## Proposals Bishopbriggs Memorial Hall

Community Presentation 18.08.2016

## **East Dunbartonshire Council**

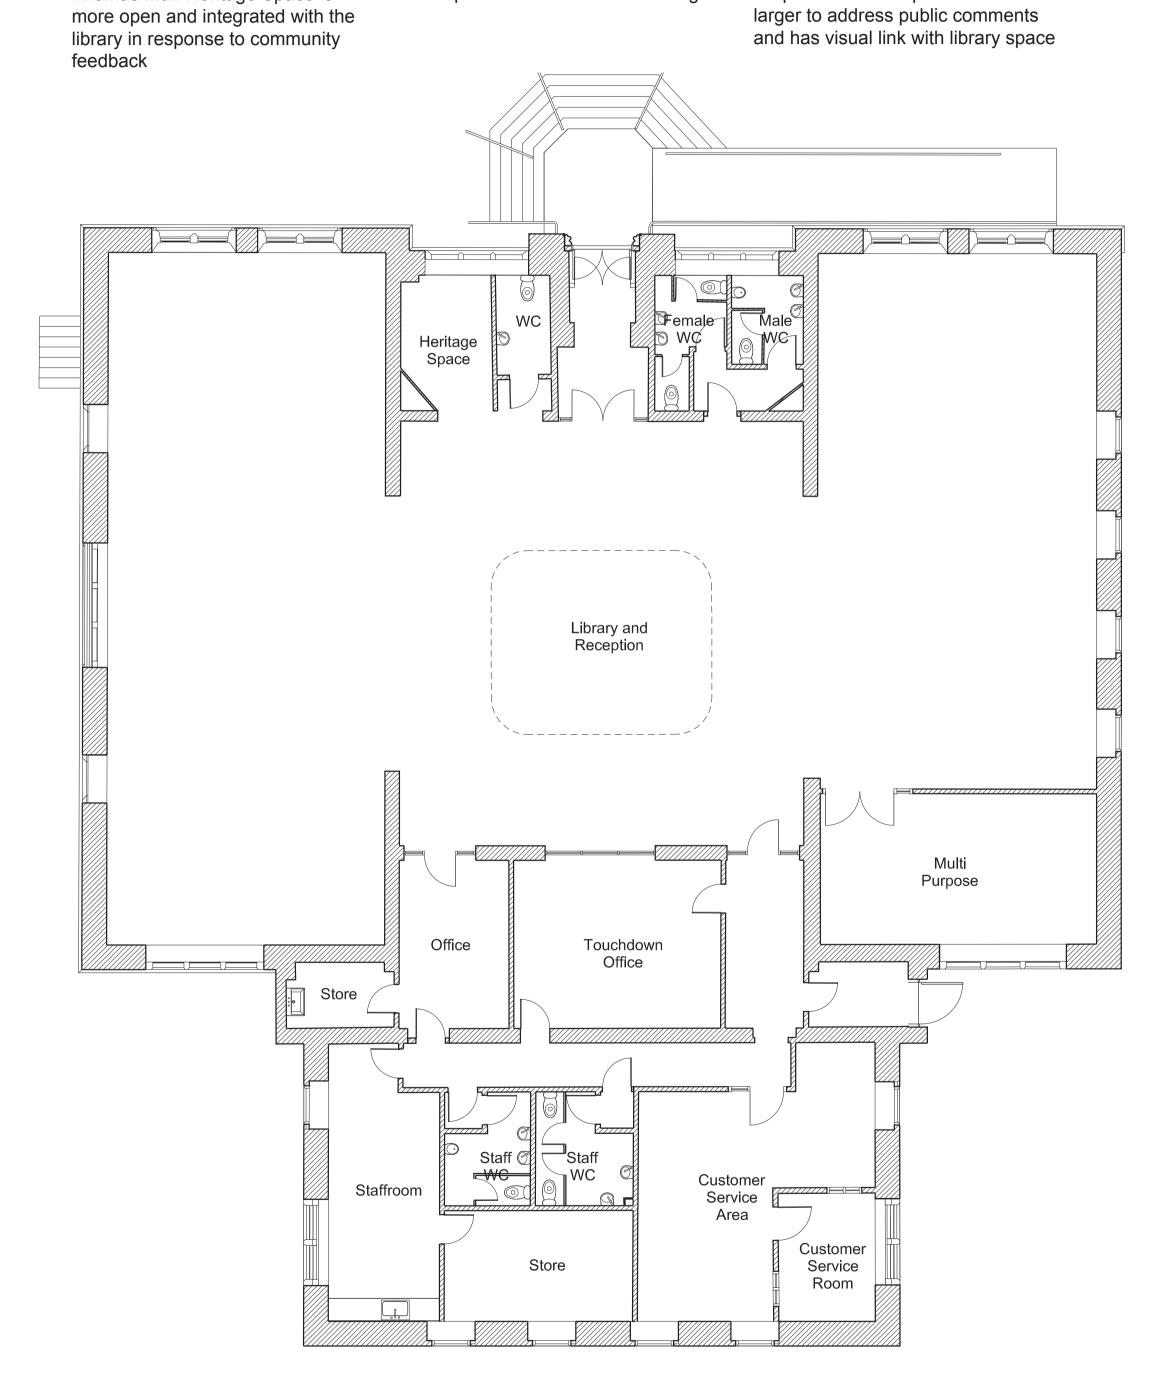
Community Hub	
Fear that number of books and library area will be greatly reduced	The main library space will not be significantly compromised and will be kept as open/ flexible as possible in response to community comments.
Soundproof rooms for Hub facilities are important	The interview and registration services rooms will provide a level of confidentially which is not currently achieved at the Hub. These rooms will have a high acoustic rating for customer privacy.
Why not show furniture in library space? What will this space be like?	This is now shown on plans to give an indication of what will be provided
Multi-purpose room is too small	The proposed multi purpose room is now larger in response to community comments
Library losing too much space to Hub – is a staff shower necessary?	This provision is part of current policy to promote healthy lifestyles and green transport
Unisex WCs are not appropriate	These are more inclusive and practical, particularly for parents and children who may not be of the same gender

Will there still be computer, photocopier, printing facilities?	Absolutely - these facilities will be located within the main library space.

Existing Plan

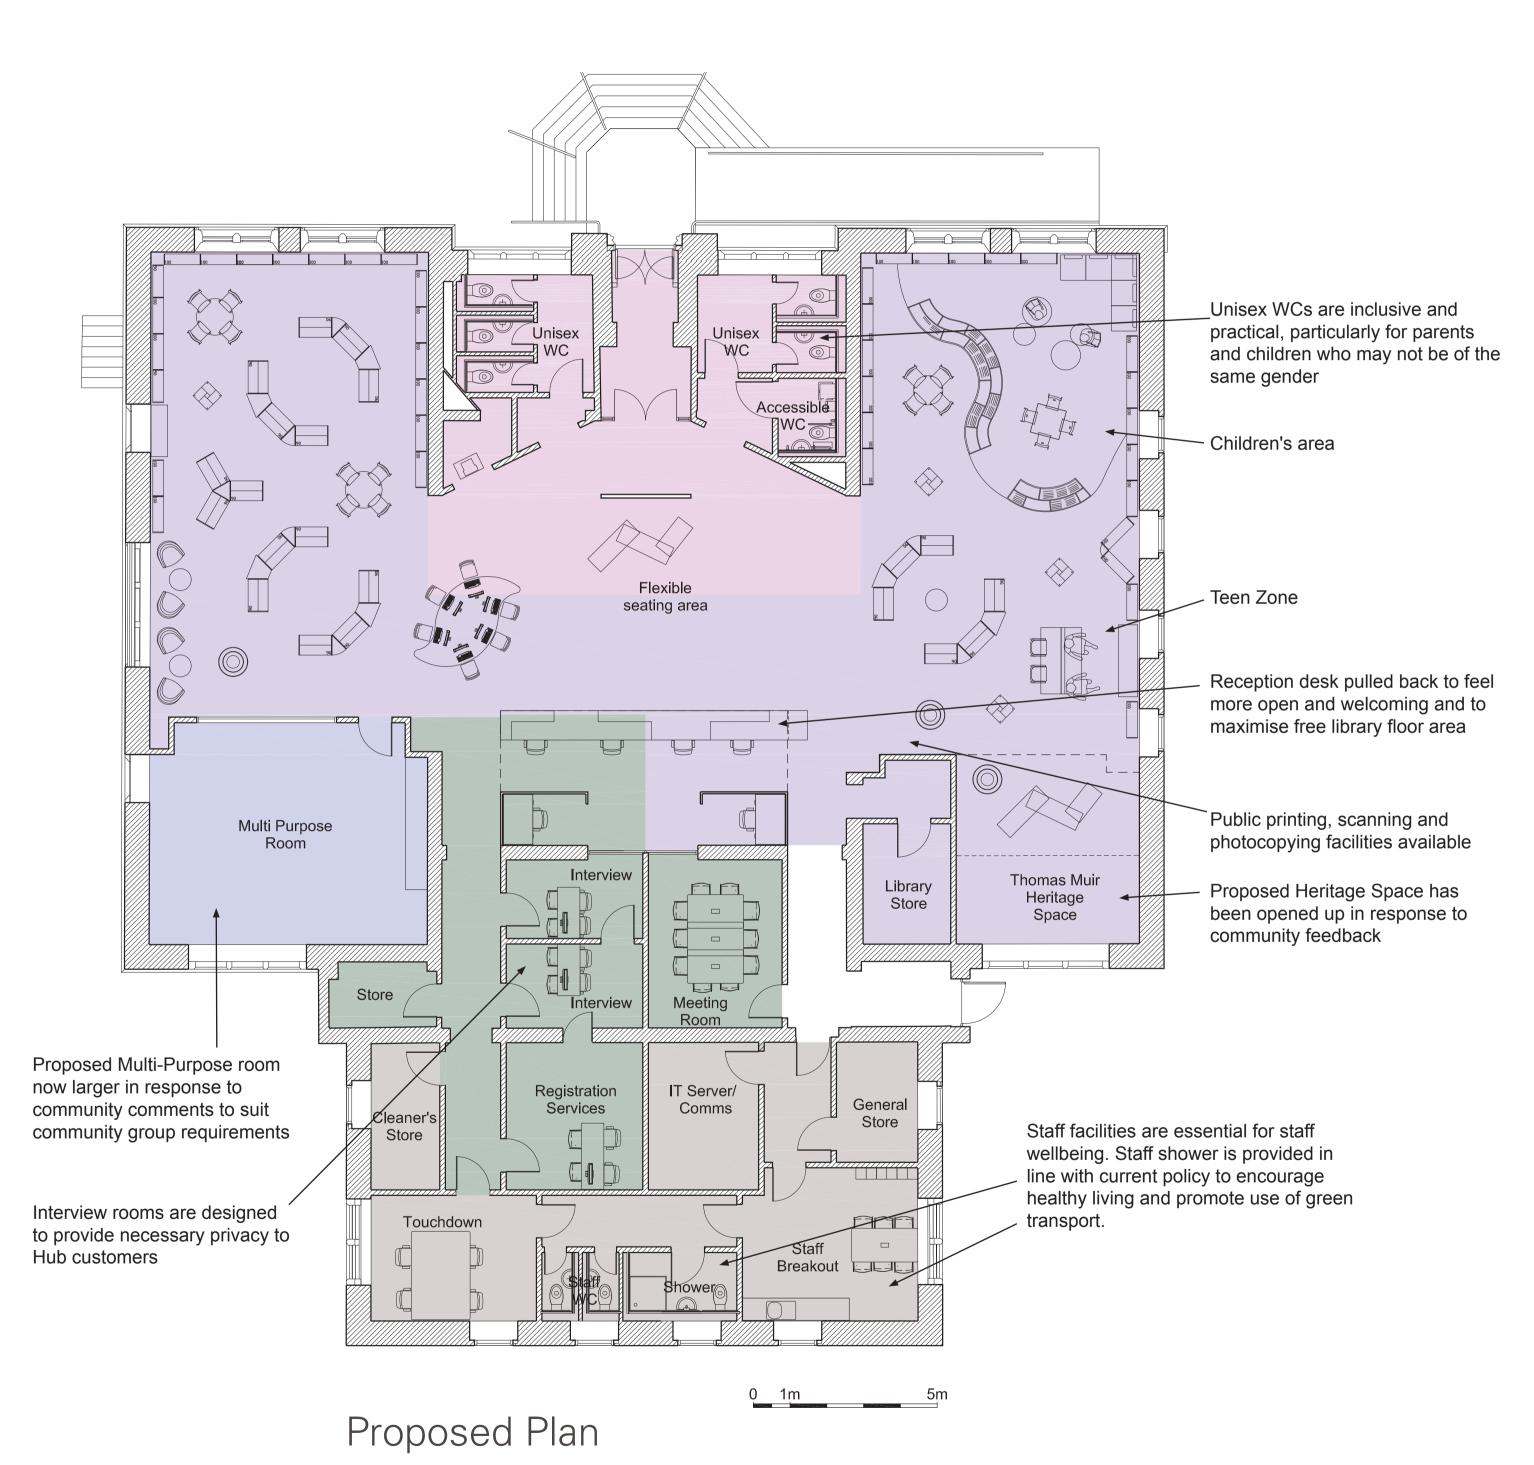
Memorial Hall	
Ceiling could be lowered in main hall to improve acoustics/ heating	The unique aesthetic character of the main hall would be lost with a false ceiling. It would not impact on the heating requirements as the space above would still be heated, unless an insulated ceiling was installed which would be of high cost. New acoustic panelling in the hall will improve the acoustic quality.
Main hall could be split by large screen	The requirement for flexible use of hall space is captured by extending the lesser hall and providing a dividing screen here. A dividing screen in the main hall would be costly and may not be often used as the advantage of having two events running simultaneously could be compromised by a lack of adequate acoustic separation within the existing structure.
Retractable seating/ demountable stage	A retractable seating system in the main hall has been considered as an option. The dimensions of the system would block the servery hatch to the new kitchen and would permanently take up floor area in the hall. Additionally the system could not be structurally supported by the existing floor which puts the seating option out of budget. Space for a demountable stage for functions and local performances will be provided.

Wheelchair access/ storage in cloakroom	Accessibility throughout the building will be dramatically improved and the cloakroom will be large enough to allow wheelchair access and storage.
Kitchen could be relocated to serve both halls	Relocating the kitchen to the other end of the main hall would mean that floor area would reduce in the lesser hall as a corridor would be needed to access the kitchen when both halls are in use. This also would mean that the natural "stage" end of the hall would be compromised by the kitchen servery. The lesser hall is not expected to require servery access to the kitchen: a counter top with sink and boiling tap is to be provided in the lesser hall and the kitcher can be accessed via the corridor.
What are the exterior proposals?	The curtain wall windows are to be replaced and the external cladding cleaned and repaired or replaced where necessary. The access road will also be addressed.

Will the kitchen/ store relocation impact on the max capacity of the Hall'	No. The area added by removing the existing stage is equivalent to the area of the kitchen and store so the capacity of the main hall will not change.
A new coffee shop/ café?	This would require a permanent lettable space which would take away area from the current proposals. The Memorial Hall is not open all the time and
